**STAFF REPORT  
KETCHUM PLANNING AND ZONING COMMISSION  
MEETING OF NOVEMBER 9, 2021**

**PROJECT:** 380 N 1<sup>st</sup> Ave Mixed-Use Building

**FILE NUMBERS:** P21-085

**APPLICATION:** Design Review

**LANDSCAPE PLAN**

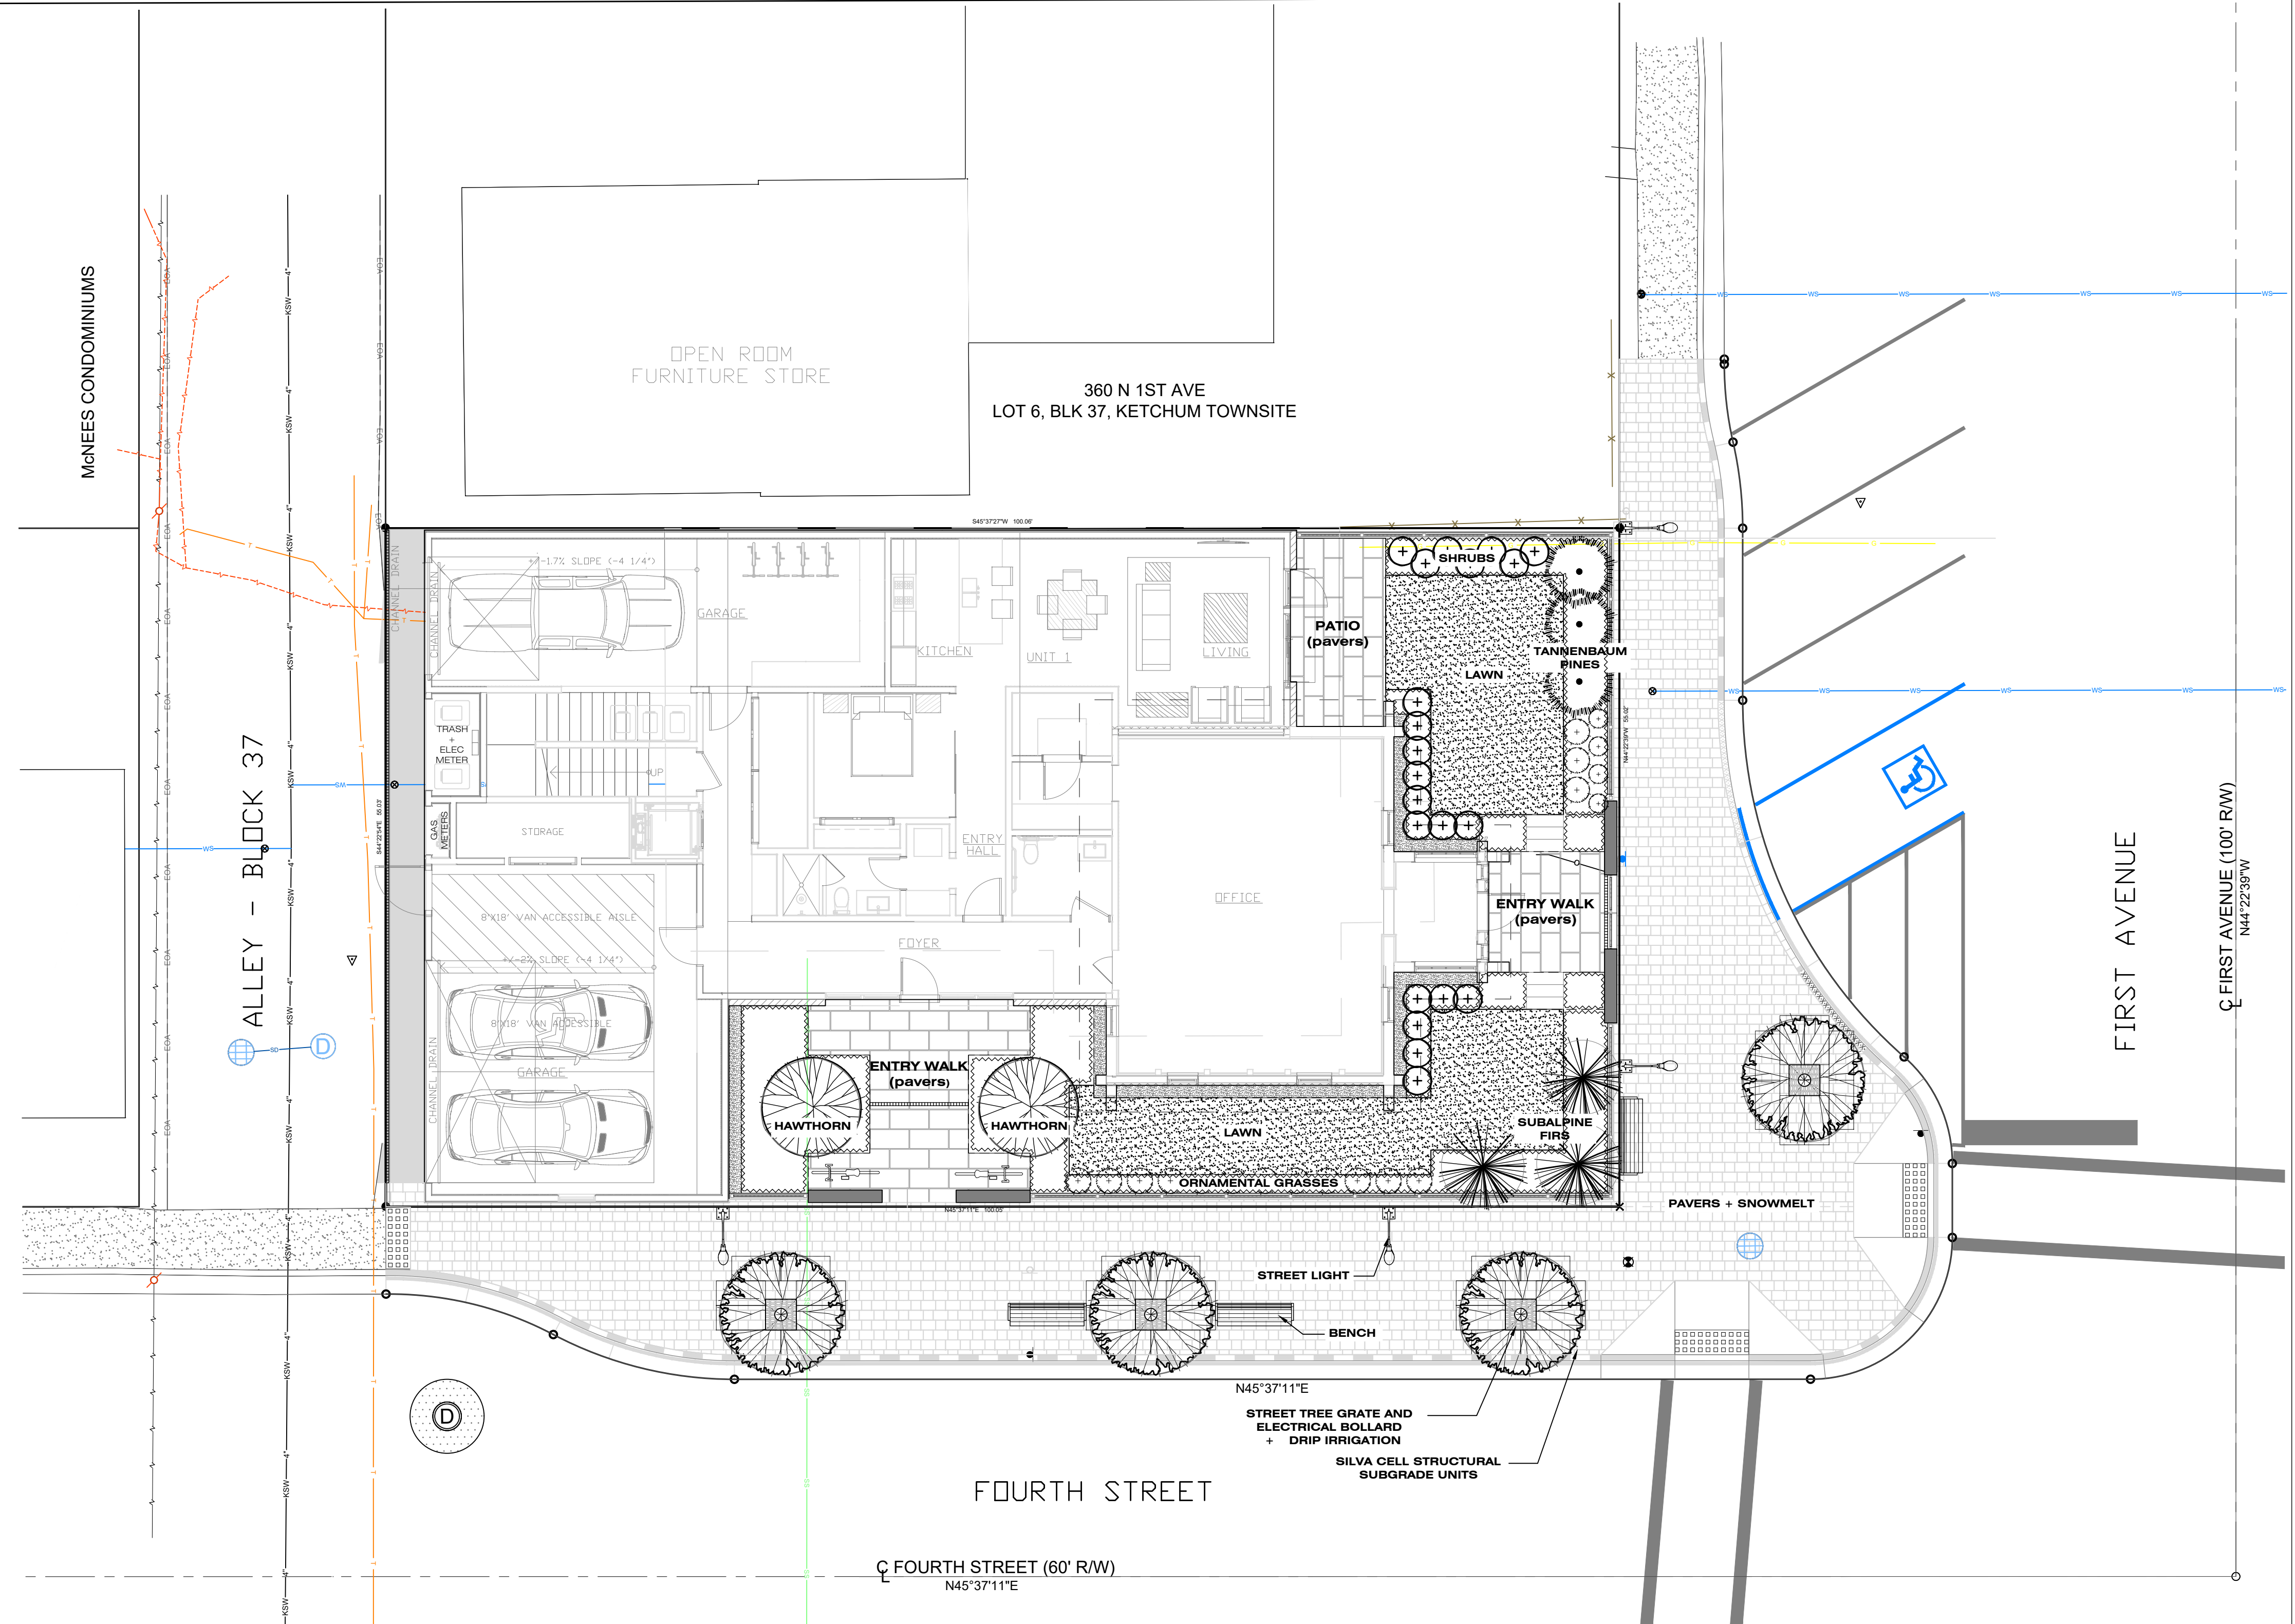
<b>Staff Comments</b>	Sheet L-3.0 specifies that the proposed Red Rocket Maple street trees will be 4-inches caliper and installed within tree grates.
<input checked="" type="checkbox"/>	<input type="checkbox"/>	<input type="checkbox"/>	<b>17.96.070(A)(3)</b>	<b>Due to site constraints, the requirements if this subsection 17.96.070(A) may be modified by the Public Works Department.</b>
			<b>Staff Comments</b>	Preliminary plans submitted with Design Review are reviewed by the City Engineer and Streets Department in concept only. Modification to the requirements of KMC §17. 96.070.A may be recommended by the City Engineer and Streets Department following review of the civil drawings submitted with the building permit application. The final civil drawings, including the streetscape, sidewalk, utilities, and drainage plans, shall be reviewed and approved by the City Engineer, Streets Department prior to issuance of a building permit for the project.
